Staff Report & Recommendation

SUBJECT: **PB21-0453, A.K.A. PB20-0352. 120 MacArthur Causeway. One Island Park.**

subject: Terminal Isles Office Space (Design 2) Traffic Engineering Review

MEMORANDUM

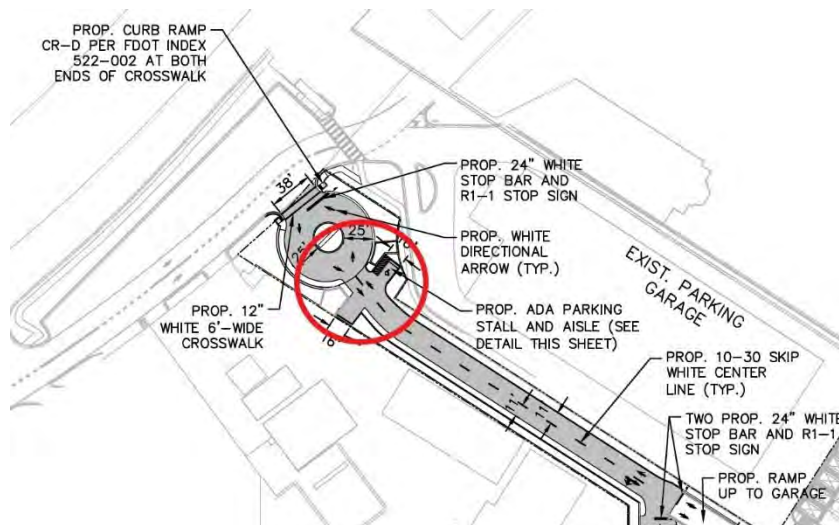
7. Please evaluate the traffic circle design to ensure proper signage is proposed per MUTCD within the traffic circle to direct vehicle traffic (i.e., arrow signage, Do Not Enter, etc.). The below pavement marking, and signage image is from the November 2021 plan. An updated pavement marking, and signage plan still needs to be submitted.

DPA's 06/06/22 Response: Please note that the area in question is not intended to operate as a typical traffic circle. It is not anticipated that traffic entering or exiting the property will be making regular U-turn movements. The intent of the proposed circular configuration adjacent to Terminal Island Drive is to allow the occasional vehicle that enters the property by mistake to quickly turn around and exit.

TCG 06/07/22 Response: Addressed.
